Serial No. NA3-08-051  
Docket No. 52-017  
COL/JPH

**DOMINION VIRGINIA POWER**  
**NORTH ANNA UNIT 3 COMBINED LICENSE APPLICATION**  
**RESPONSE TO REQUEST FOR ADDITIONAL INFORMATION LETTER NO. 004**

**RAI Question 11.02-1**

Figure 9.2-203 Sanitary Waste Discharge System Simplified Diagram

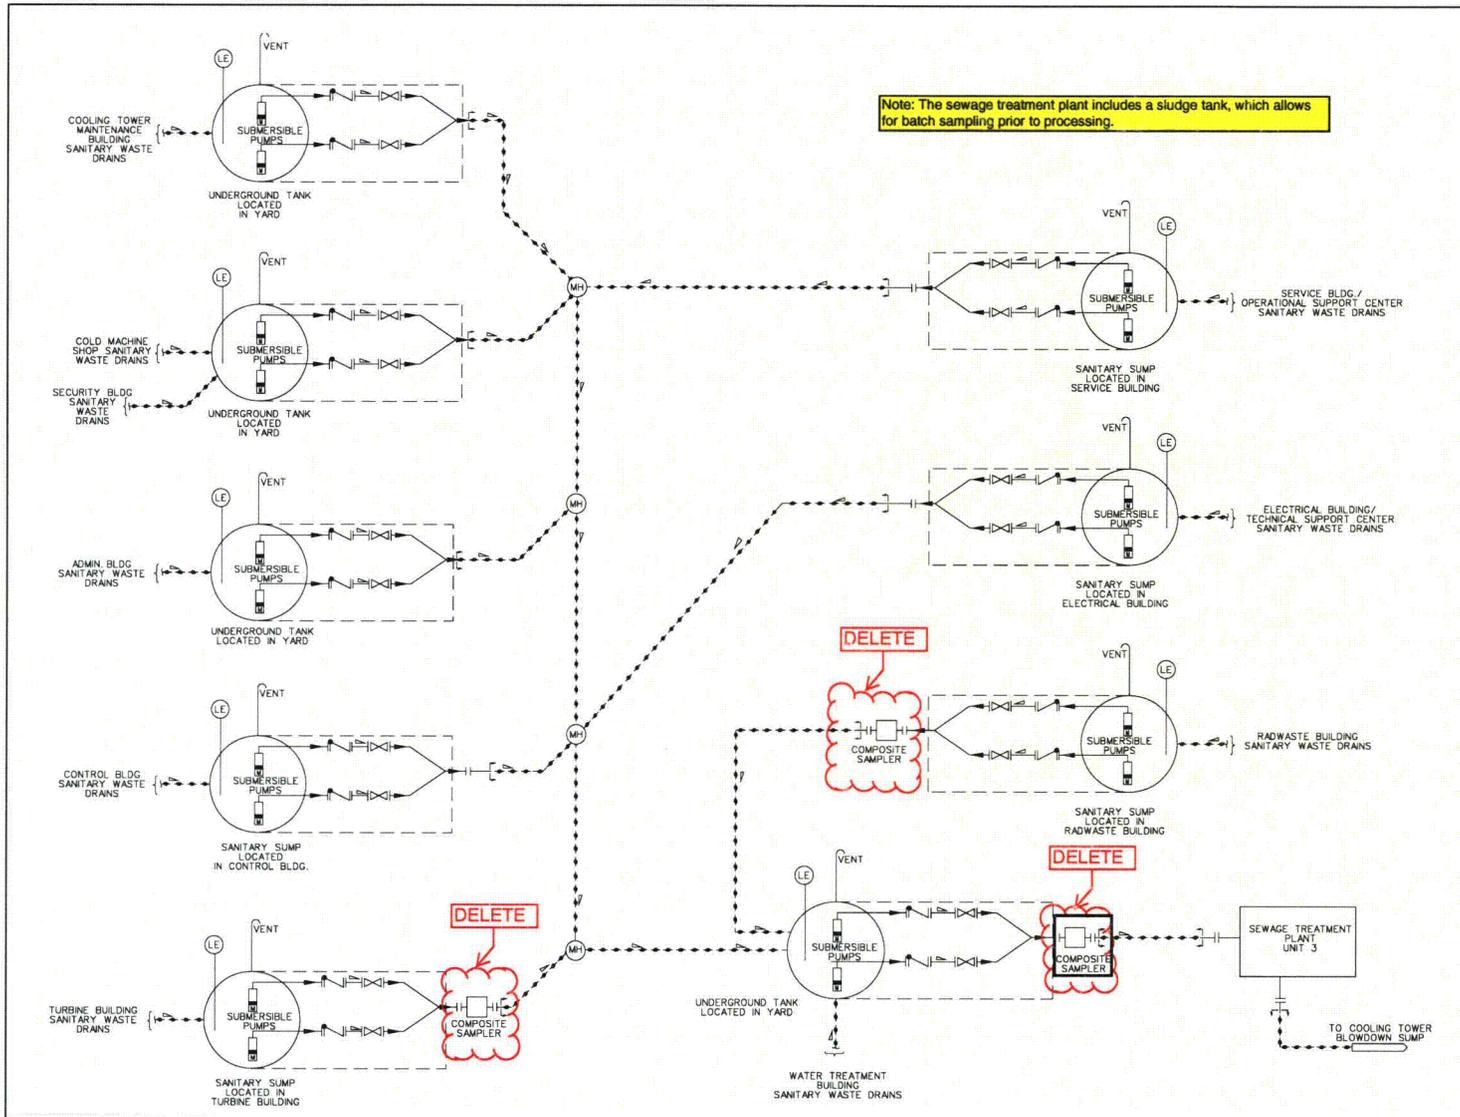
No capability for continuous sampling is required because the STP sludge tank contents are treated as a batch. The installation of composite samplers in the sanitary waste lines is not warranted. Accordingly, FSAR Section 9.2.4 and Figure 9.2-203 will be revised and the continuous samplers removed. The use of per batch grab samples to meet IE Bulletin 80-10 will be added to this FSAR section.

The SWDS is not designed to handle radioactive fluids. It is neither connected to, nor does it interface with, any system that may contain radioactive fluids. As a precautionary measure ~~and as shown in Figure 9.2-203, the SWDS effluent is monitored,~~ the STP sludge tank is grab sampled on a batch basis for potential radiological contamination ~~at several locations in the sanitary waste lines to the STP.~~ In the event radioactivity is detected above ~~preset~~ predetermined limits, controls are in place to ~~prevent offsite disposal of sewage sludge prior to on site evaluation of potential radiological contamination and treatment when contamination is beyond acceptable limits~~ initiate treatment and prevent unmonitored; uncontrolled radioactive releases to the environment.

FSAR Section 9.2.4.2 and Figure 9.2-203 will be revised as indicated in the attached markup. The continuous samplers will be removed and the use of grab samples to meet IE Bulletin 80-10 will be added to this FSAR section.

~~sanitary waste.~~ Analysis of routine STP sludge tank grab samples will detect events that might contaminate the STP downstream of the sludge tank. This provides the action required by Inspection and Enforcement Bulletin No. 80-10. The quality of effluent meets, at a minimum, the standards established by Federal, state, and local regulations and permits. Sewage sludge is transferred to a truck for off-site disposal. A simplified diagram of the SWDS is shown in Figure 9.2-203.
